### Proposed Revisions to a Standard Plans Index

Index Number: 400-090  
Sheet Number (s): 1  
Index Title: Approach Slabs (30ft) (Flexible Pavement Approaches)

**Summary of the changes:**

Broke note 9 into 2 notes.

INDEX	SHEET
400-090	1 of 2

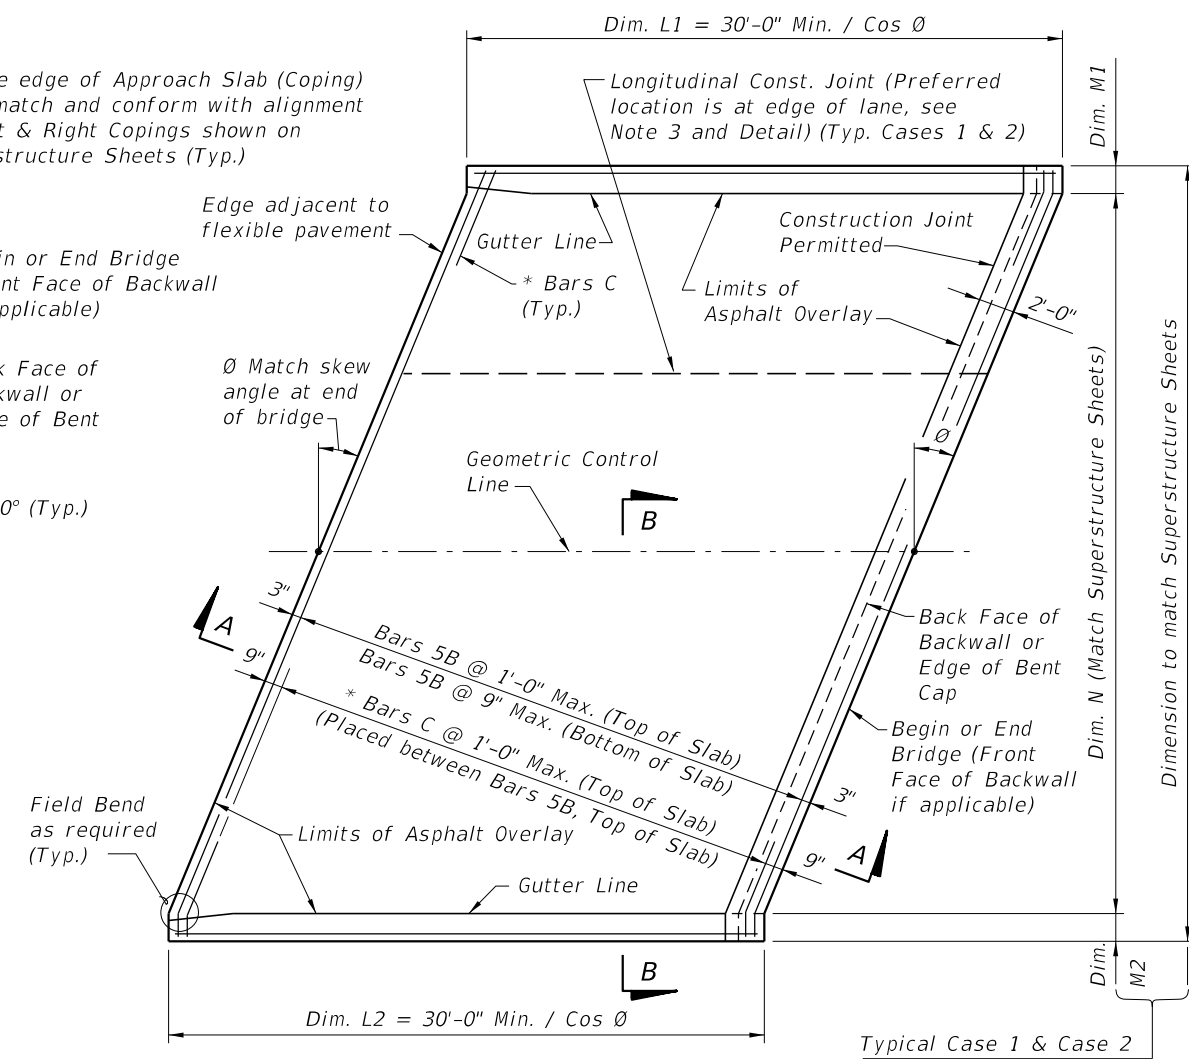
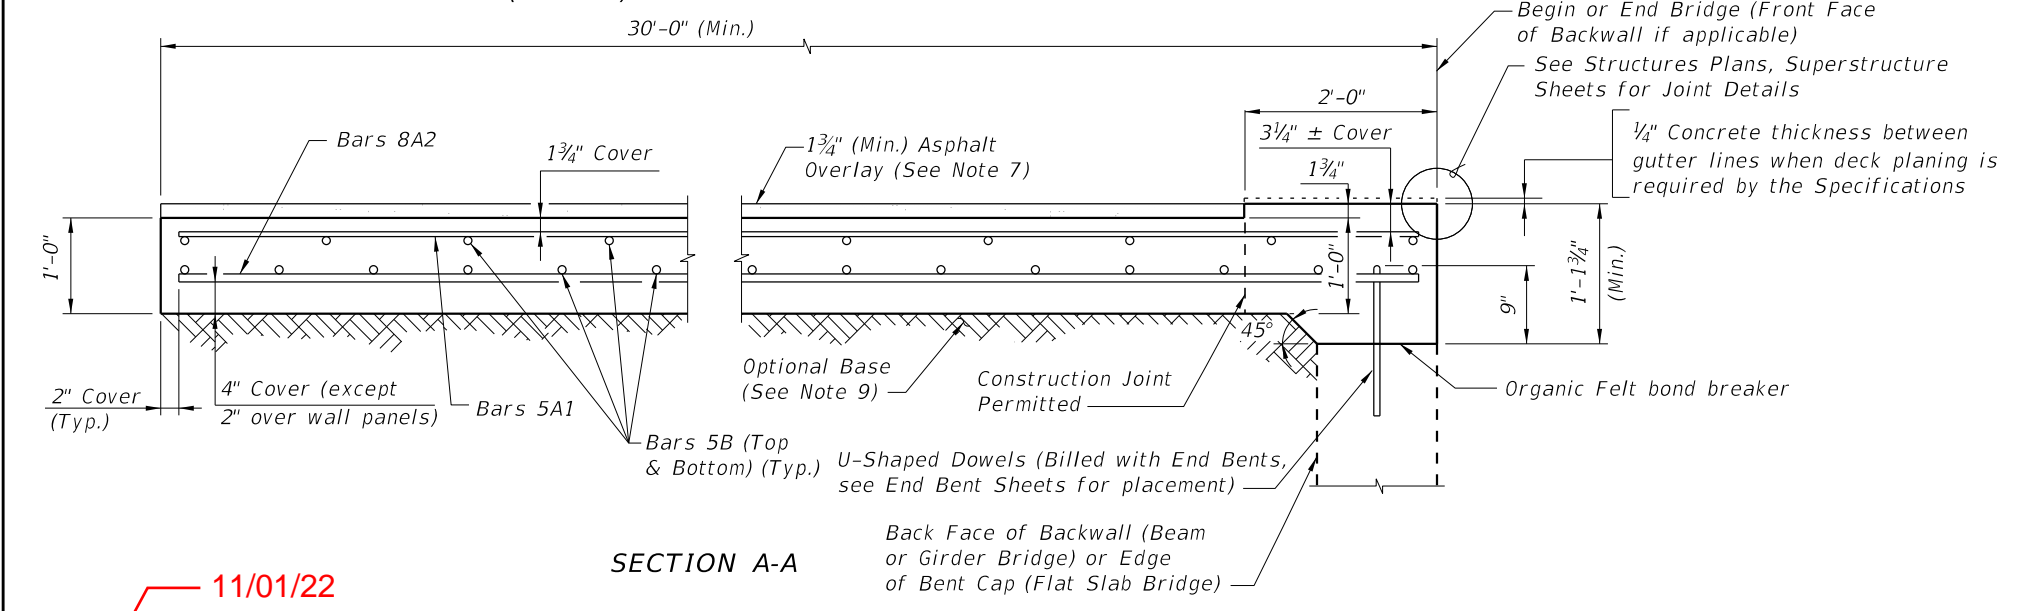
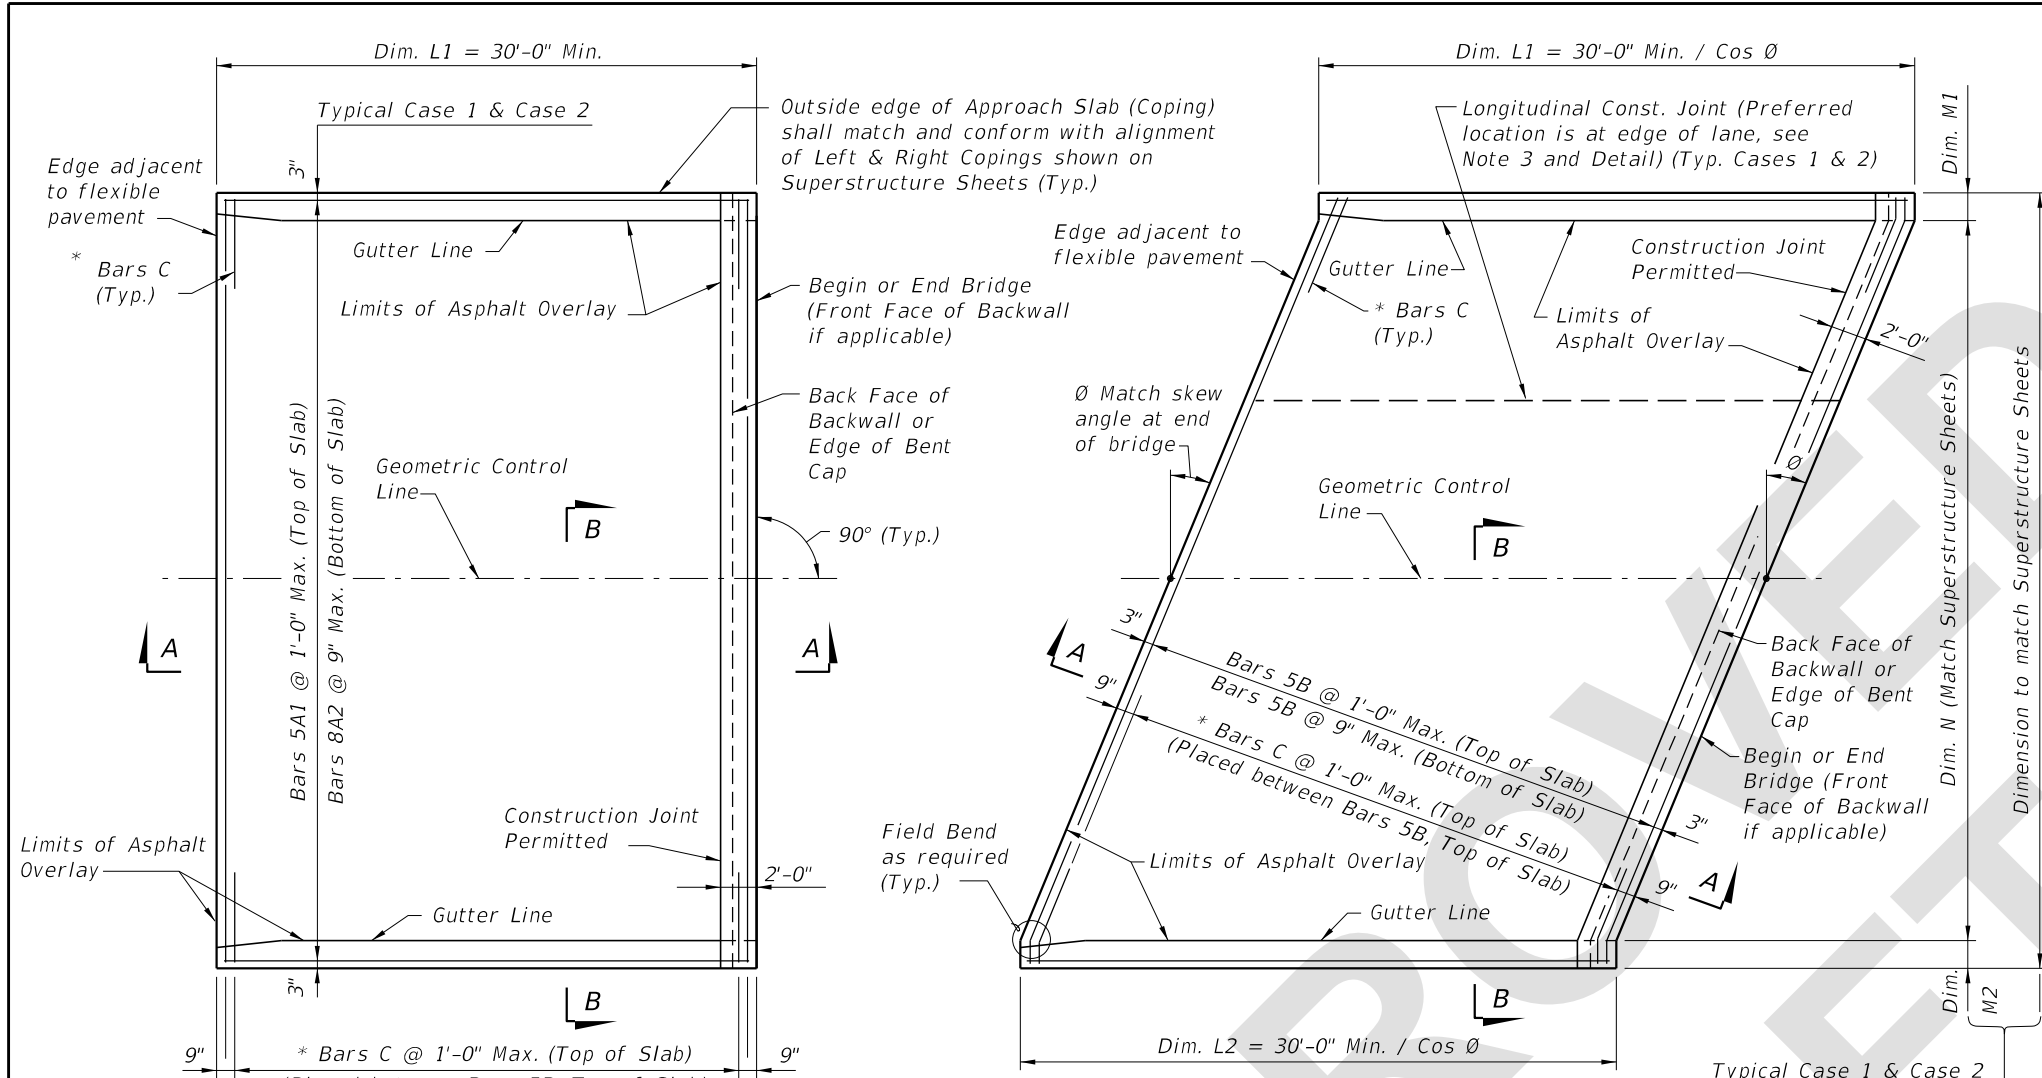
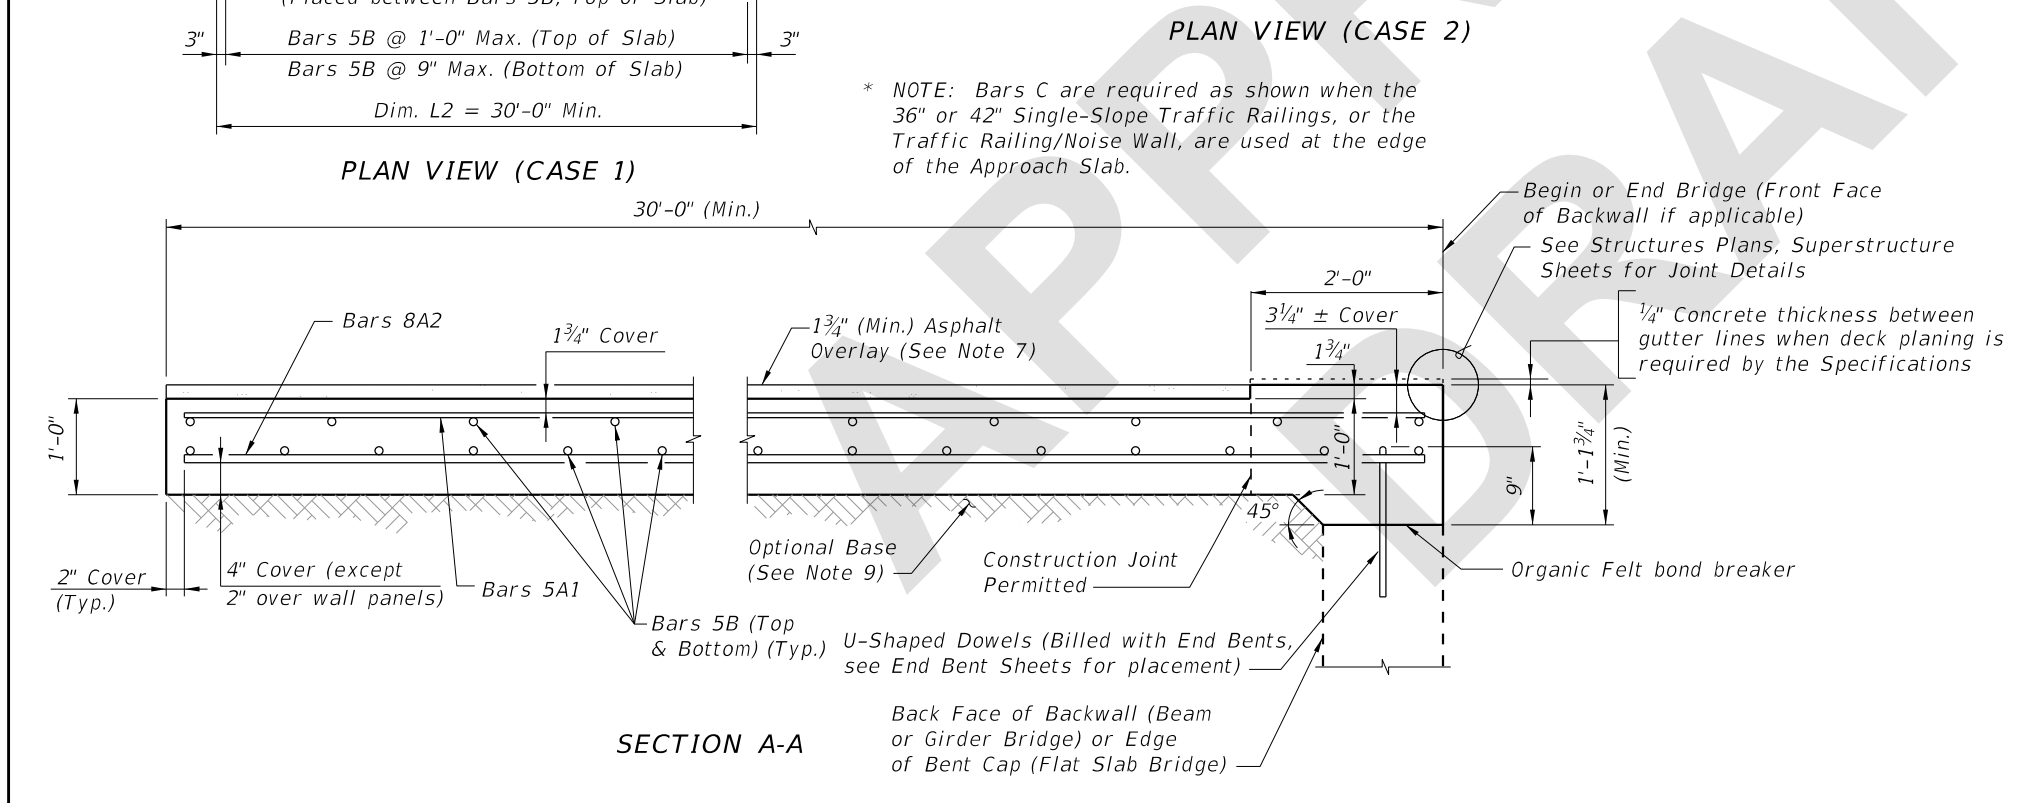
9. PAYMENT: Deformed WWR for the edge of Approach Slabs on retaining walls is not included in the estimated quantity for reinforcing steel and is considered incidental to the work. See Roadway Plans for Asphalt Overlay and Optional Base details and quantities.

Separate and make note 10

- PAYMENT:** Deformed WWR for the edge of Approach Slabs on retaining walls is not included in the estimated quantity for reinforcing steel and is considered incidental to the work.

- See Roadway Plans for Asphalt Overlay and Optional Base details and quantities.
